**Chemung County Stormwater
Construction Inspection
Erosion and Sediment Control**

Project Name Barrington Lot 54	Date 8/3/2022
Location Wexford Court Horseheads, NY	Permit # NYR11f212
Weather Conditions sunny	Entry Time: 9:36 am
On-Site Representative Present: Brad Kapral	Exit Time: 9:47 am

PROJECT: Barrington West Lot 54
Town of Horseheads
Municipal Inspection
August 3, 2022

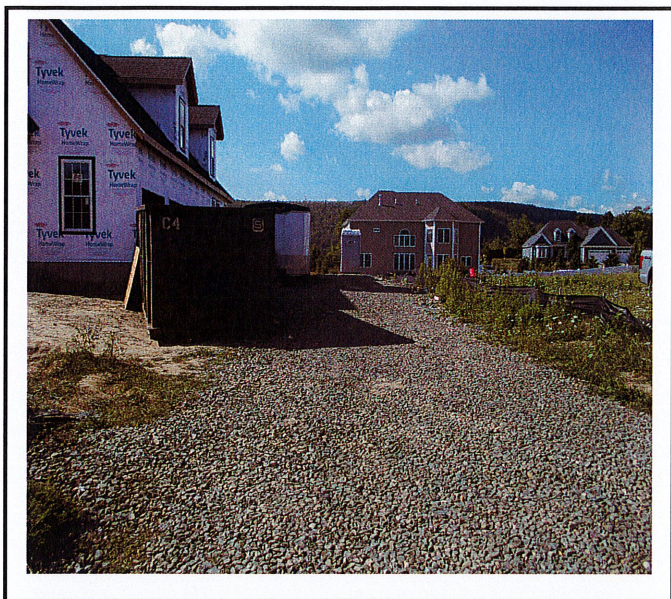
Construction entrance is functioning.

Open soil needs to be stabilized to prevent erosion.
